**SITE PLAN REVIEW SHEET  
ENVIRONMENTAL VARIANCE REQUEST ONLY**

**CASE:** SP-2020-0038C

**PROJECT NAME:** Concordia University Campus Residence Hall

**DESCRIPTION OF VARIANCE:**

## CUT-FILL MAP

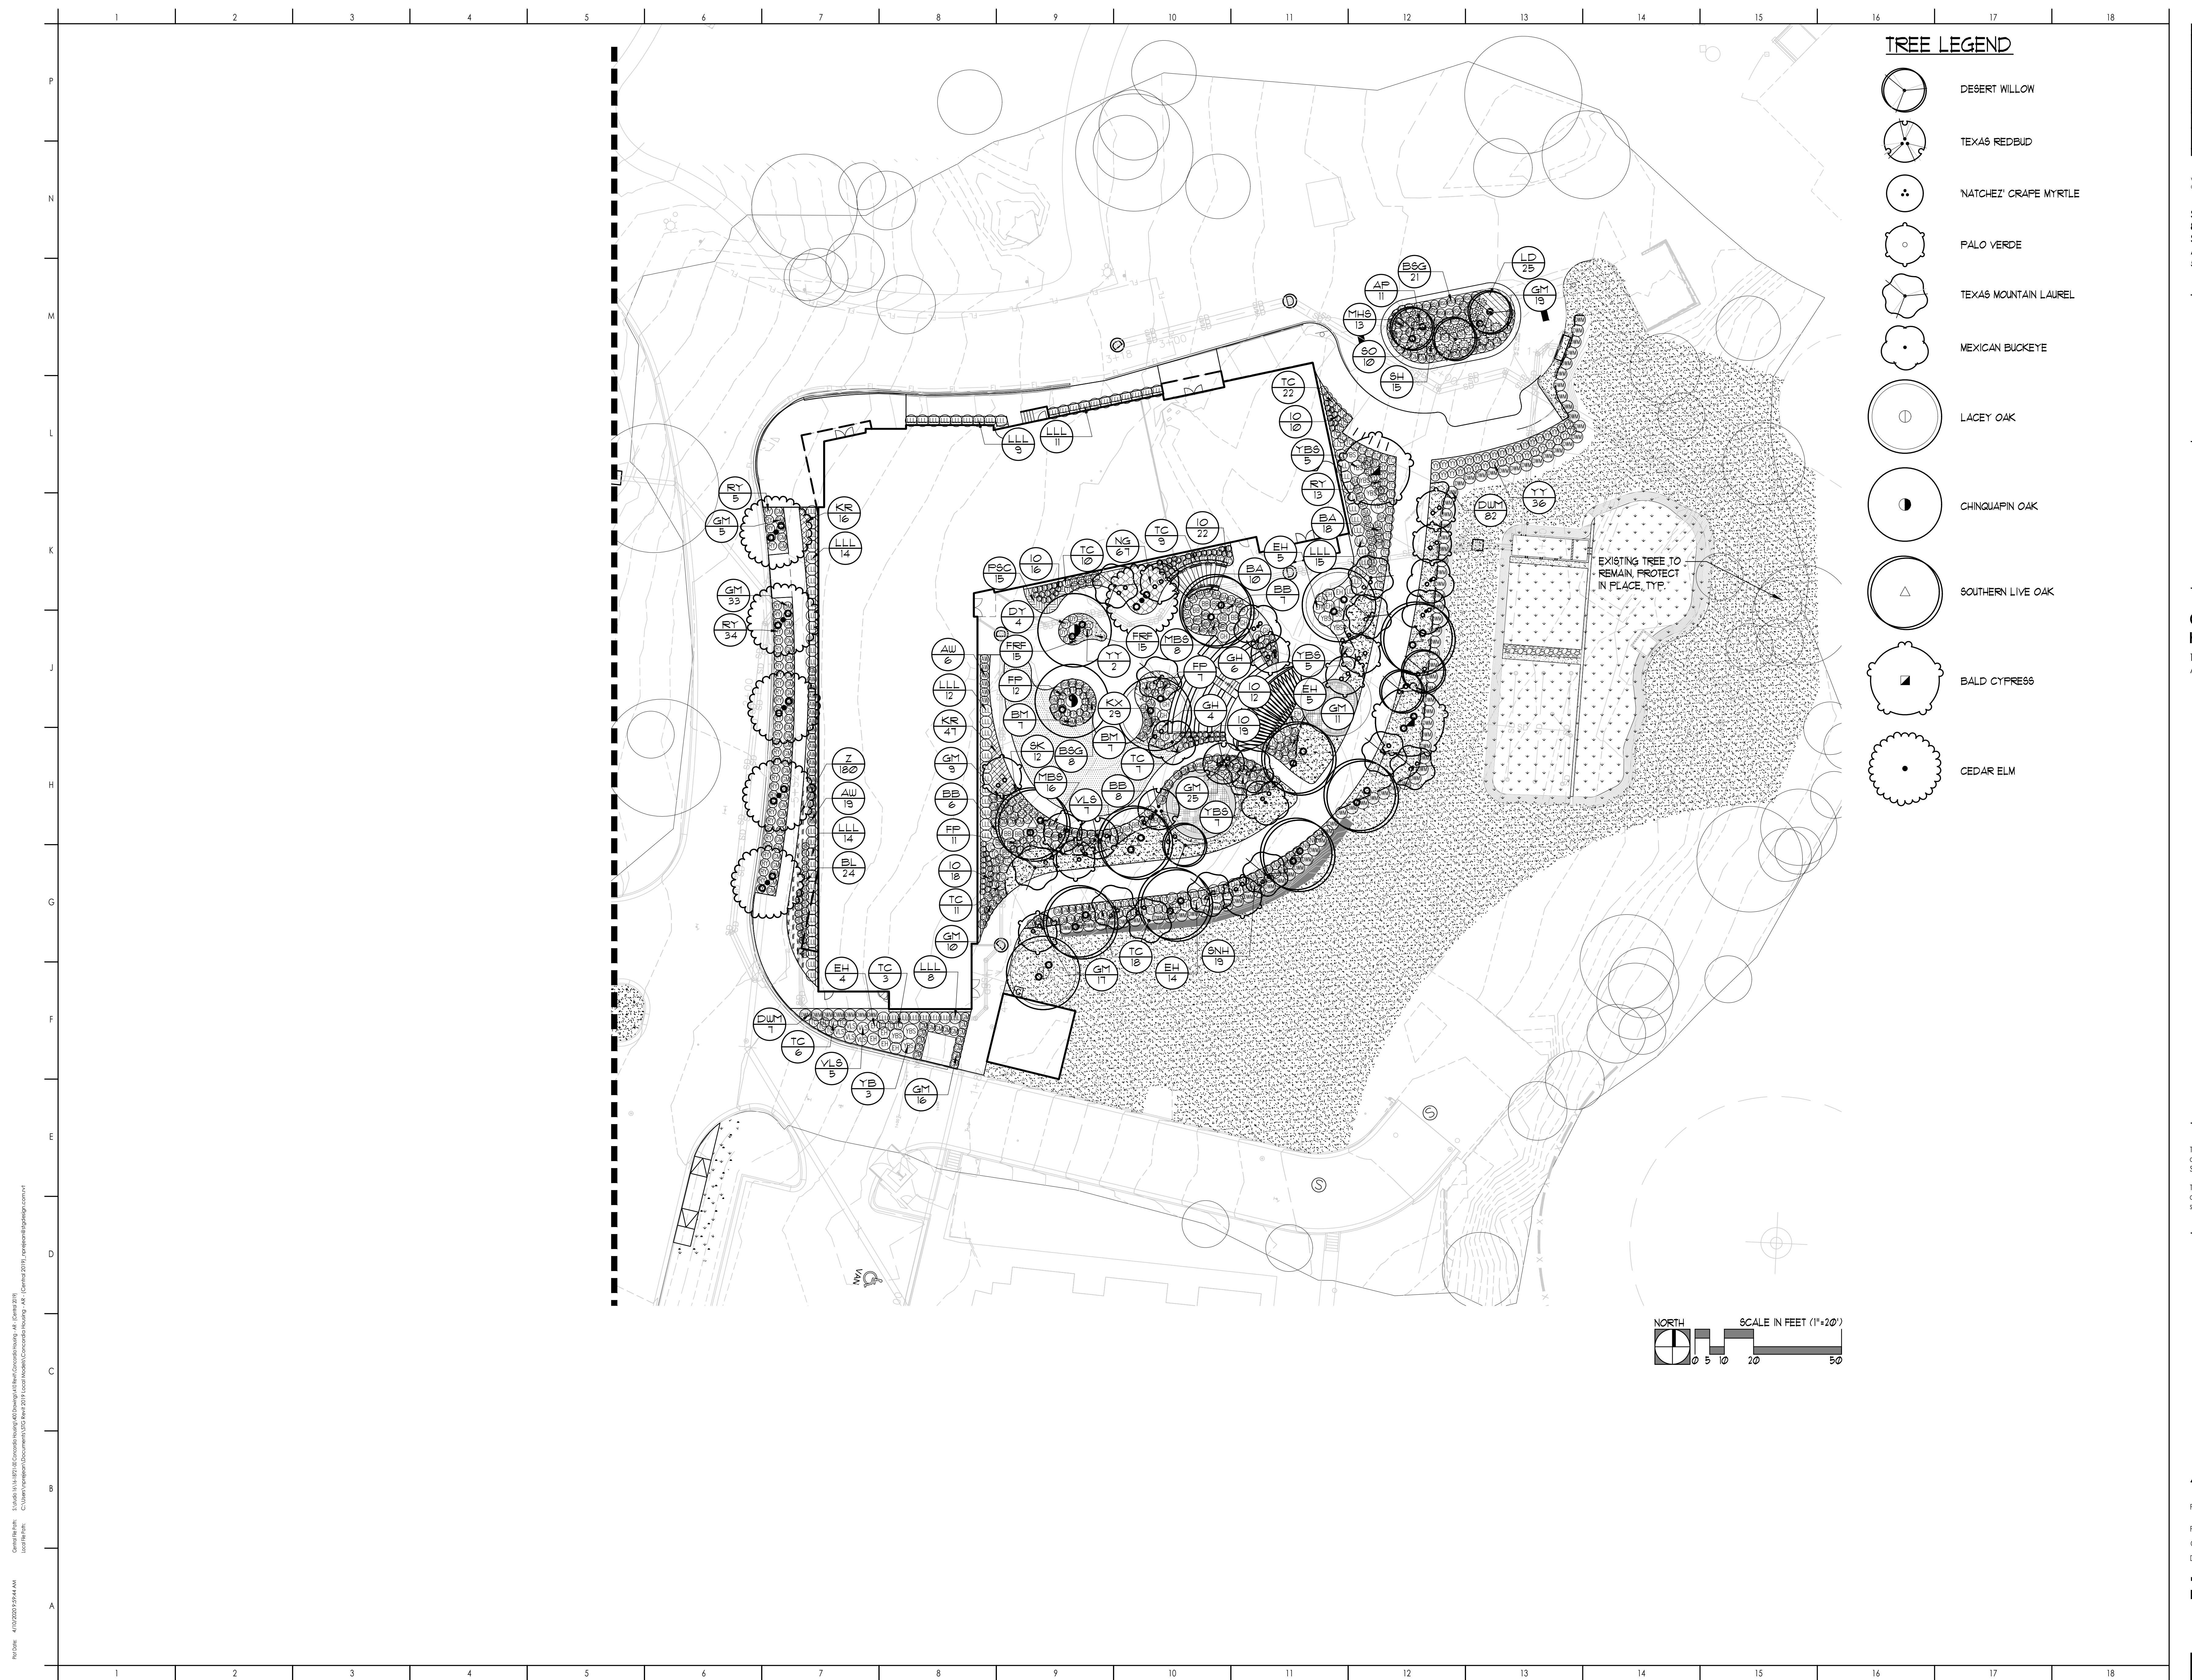
- Section 9-10-409(a) – for a fill exceeding four feet
- Section 9-10-409(b) – for a cut exceeding four feet

Clearly indicate in what way the proposed project does not comply with current Code (include maps and exhibits)	The proposed cut and fill does not comply with the applicable code for the project. Cut and fill is restricted to 4' max per the Lake Austin Ordinance #840301-F, Sections 9-10-409(A) and 9-10-409(B). The proposed project proposes a max fill of +/- 8.75 ft in order to construct a water quality and detention facility, a 4-story residence hall, and the associated parking for the +/-68,618 gsf residence hall.
---	--

- 1) Subject to the Void and Water Flow Mitigation Rule (City Environmental Criteria Manual 1.12.0 and City Standard Specification Manual No. 658S) provision that all trenching greater than 5 feet deep must be inspected by a Texas Professional Geoscientist or their representative;
- 2) Preserve top 10 inches of topsoil to be used onsite; and
- 3) Increased tree mitigation and landscaping for areas of fill to stabilize erosion as shown on landscape plan submitted in this variance packet

L-201

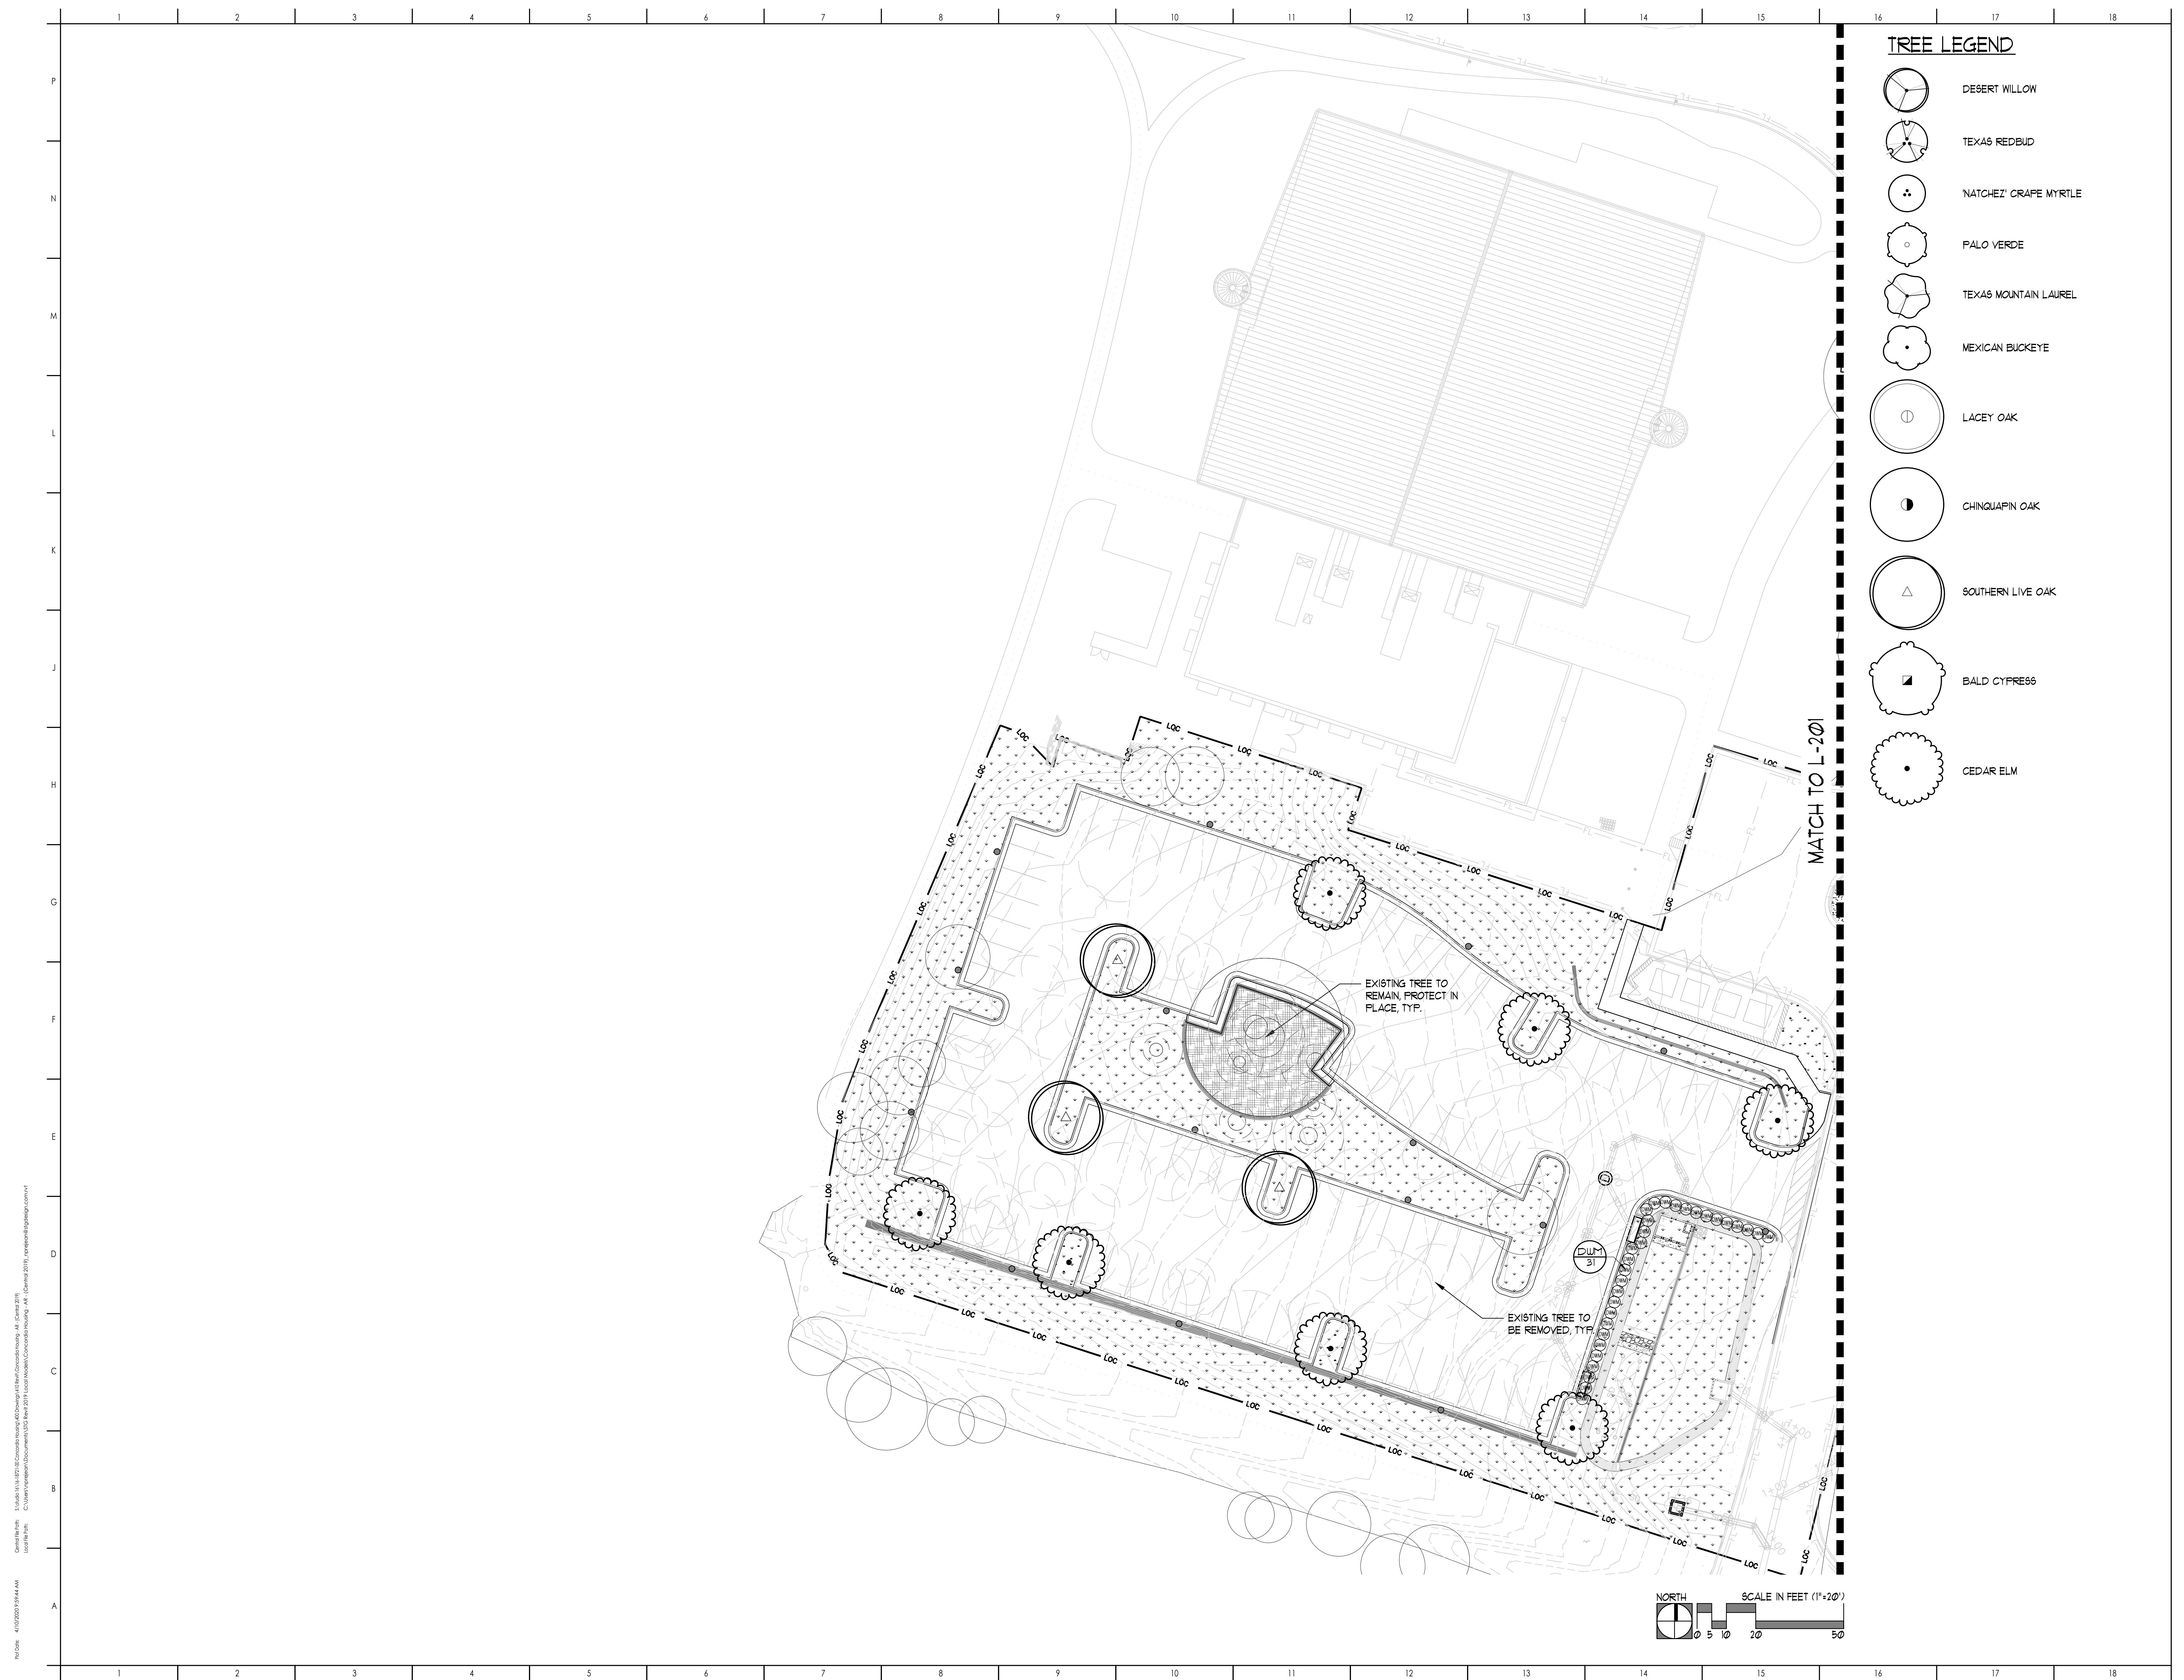
1. Subject to the Void and Water Flow Mitigation Rule (City Environmental Criteria Manual 1.12.0 and City Standards Specification Manual No. 658S) provision that all trenching greater than 5 feet deep must be inspected by a qualified Texas Professional Geoscientist or their representative;
2. Preserve the top 10 inches of topsoil to be used onsite; and
3. Increased tree mitigation and landscaping for areas of fill to stabilize erosion as shown on landscape plan submitted in this variance packet.
